Subject: AP1000 COL Standard Design Change Resubmittal of Sensitive and Non-Sensitive
Versions of APP-GW-GLR-016, Revision 0

APP-GW-GLR-016, Rev. 0

“AP1000 Pressurizer Design”

AP1000 Pressurizer Design

Figure 5.4-5

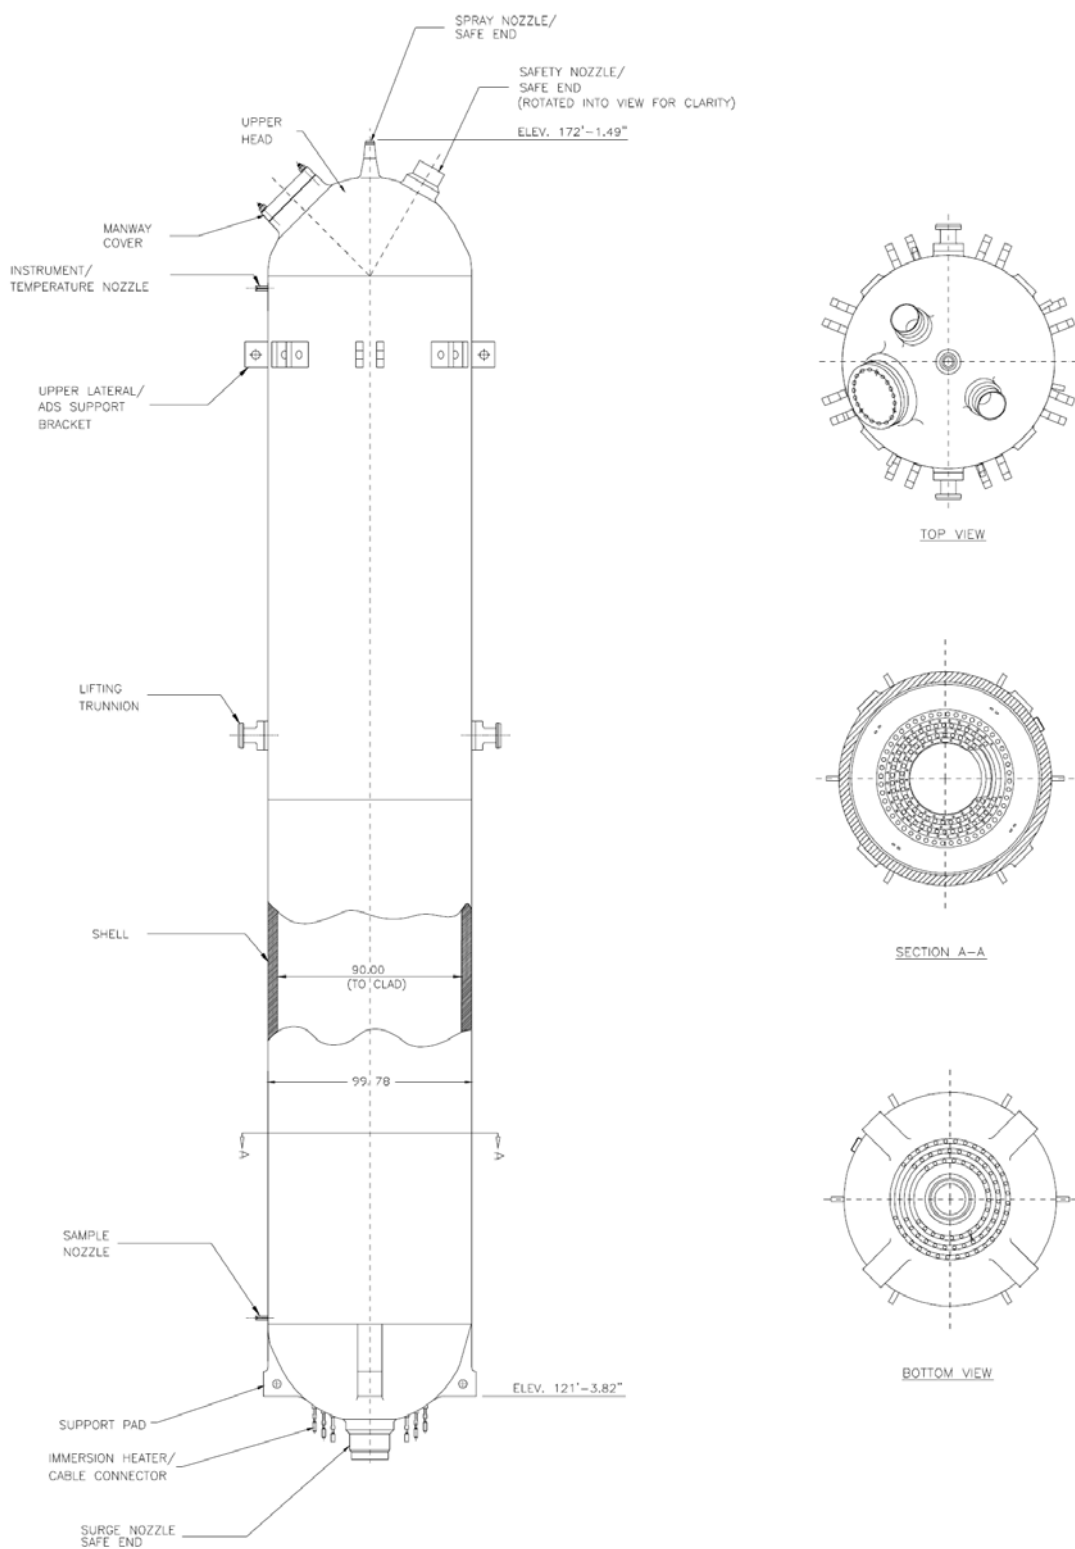
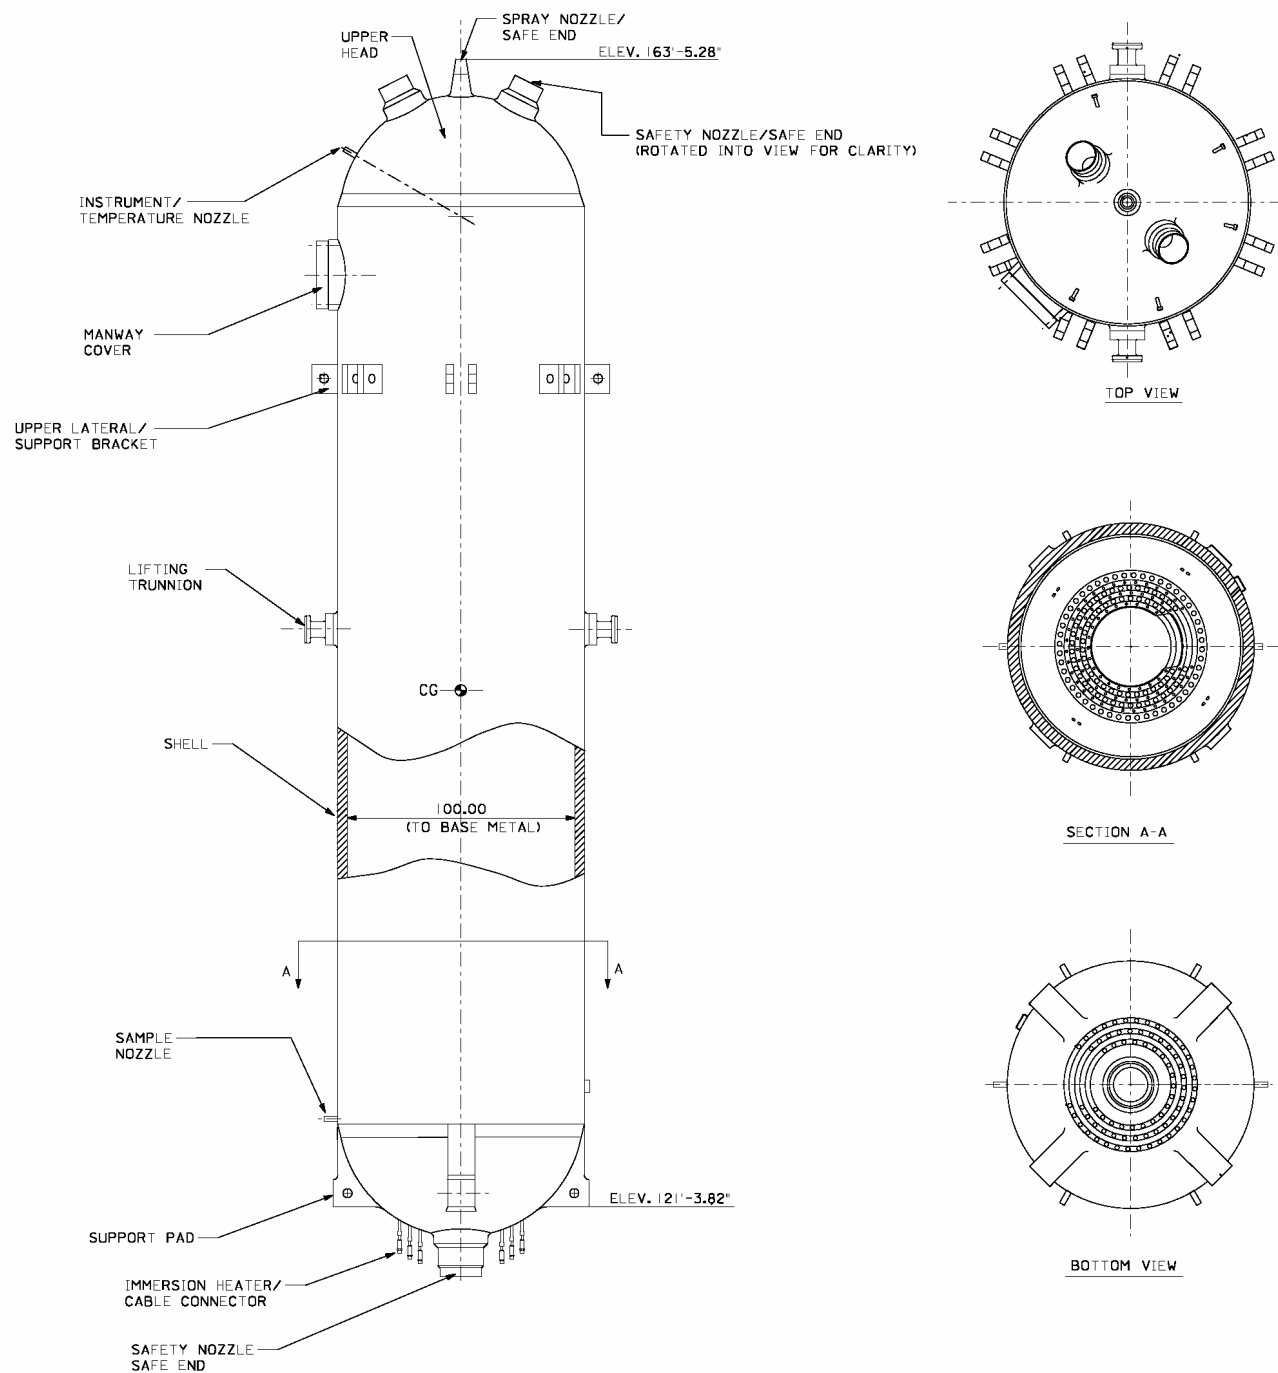
As outlined in Table 5.1-2 of the DCD, the inside diameter of the pressurizer was increased from 90 inches to 100 inches and the vessel height was decreased from 607 inches to 503 inches. The internal volume of the pressurizer was held constant. Also, the pressurizer spray capacity in Table 5.1-2 was incorrectly shown to be 500 gpm. This value was changed to the correct value of 700 gpm.

The pressurizer manway inside diameter was reduced in size from 21.00 inches to 18.00 inches. The purpose of reducing the size of the man-way was to meet a Utility Requirements Document (URD) requirement to “use essentially the same design and support equipment as used for the steam generator manways.” Therefore, the design configuration for the AP1000 pressurizer manway, manway cover, manway studs and nuts are to be identical to the manway configuration that was established for the AP1000 steam generator.

The upper four level instrumentation nozzles and the upper temperature nozzle were moved from the cylindrical portion of the pressurizer to the upper spherical head. The nozzles were moved to the upper spherical head due to interference with the installation of the pressurizer ring girder support during installation.

Figure 3.8.3-1 (Sheet 6 of 7)

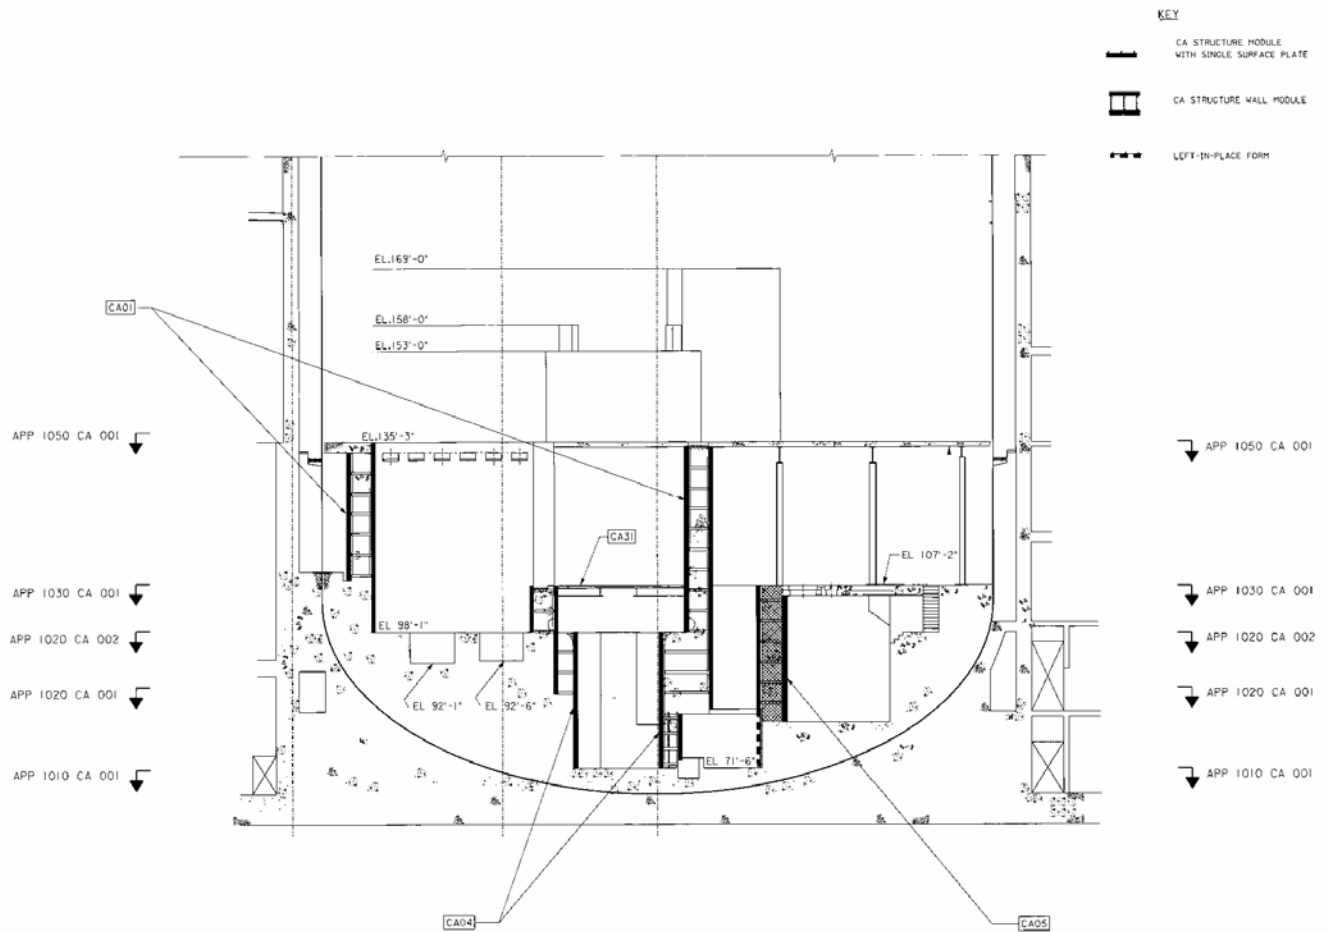
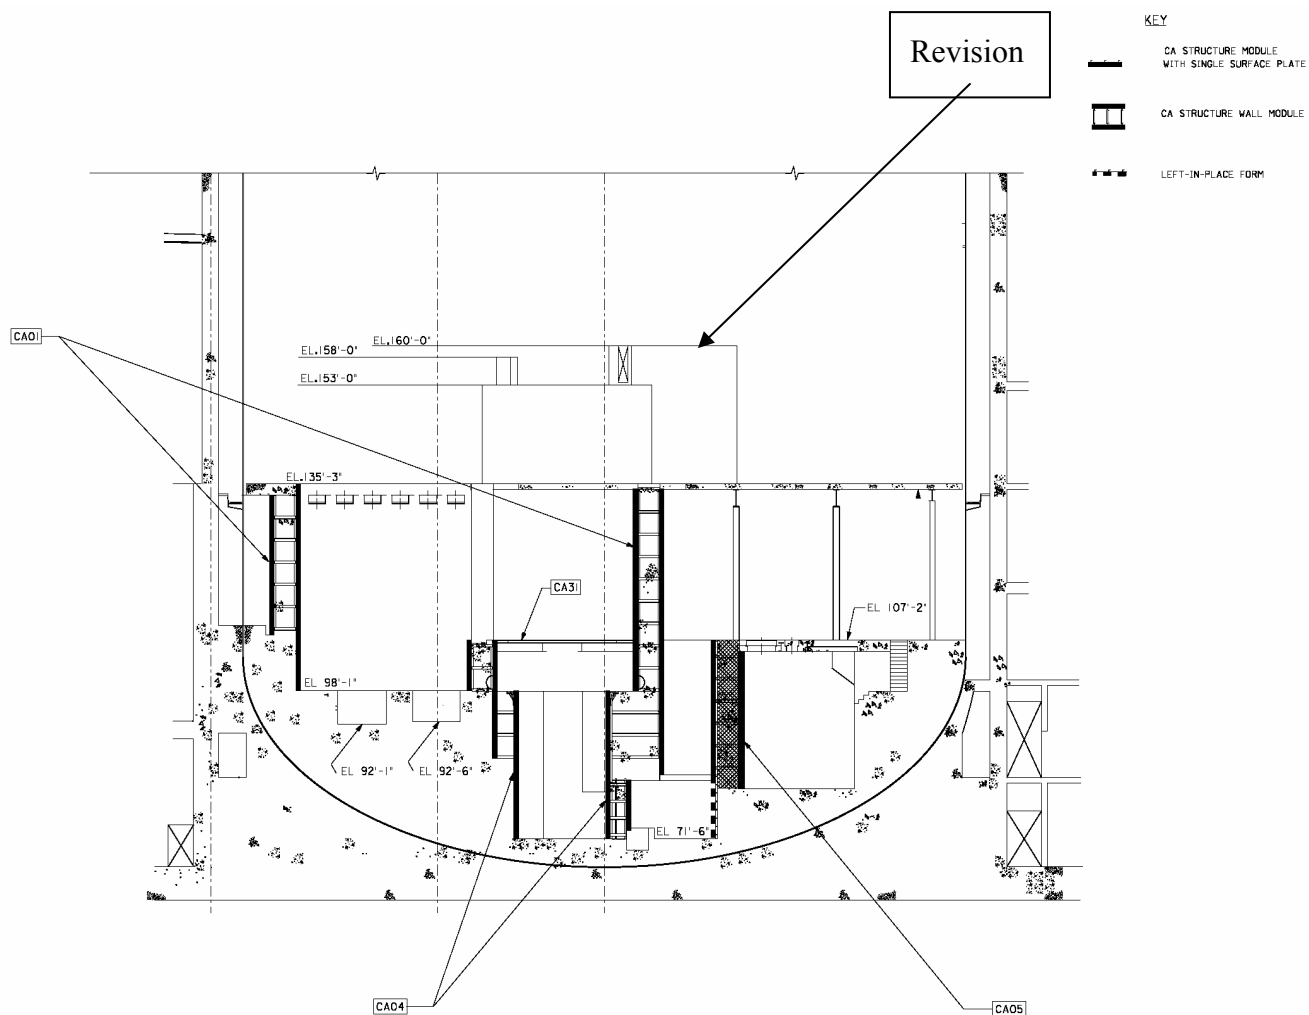
The elevation at the top of the pressurizer compartment wall will change from El. 169'-0" to El. 160'-0" due to the changes in pressurizer vessel height. The south wall shared with the steam generator compartment will change from El. 153'-0" to El. 153'-6". Also, a new platform is required in the upper southwest corner of the pressurizer compartment at El. 152'-0" and at the
